INNOLUX INNOLUX DISPLAY CORP.	工程變更客戶通知書 Engineering Change Notices to Customer	保管單位 Storage	AVQA/ CS
		保存年限 Retention Period	3 年

7DD AT070TN92 生產廠區變更,生產地增加南京廠, 部份物料導入當地供應商
7DD AT070TN92 Module production site change from Foshan(FS) to Nanjing(NJ),
Some of materials will introduce the local vendor for substitution.

7DD AT070TN92: Production factory will transfer from FS(佛山) to NJ(南京)

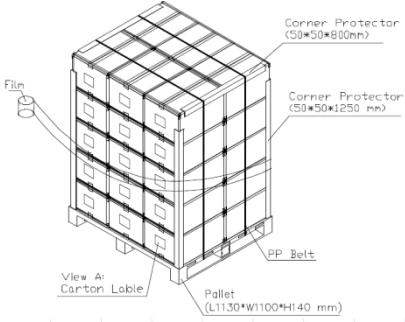
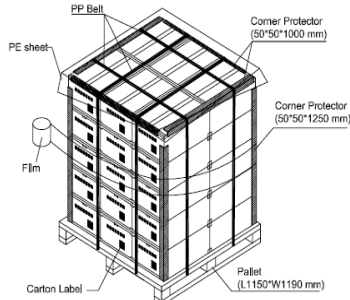
(1~3)In order to company strategy, "AT070TN92" production factory will transfer from FS(佛山) to NJ(南京)

(4~12) Plan to introduce the local vendor for substitution.
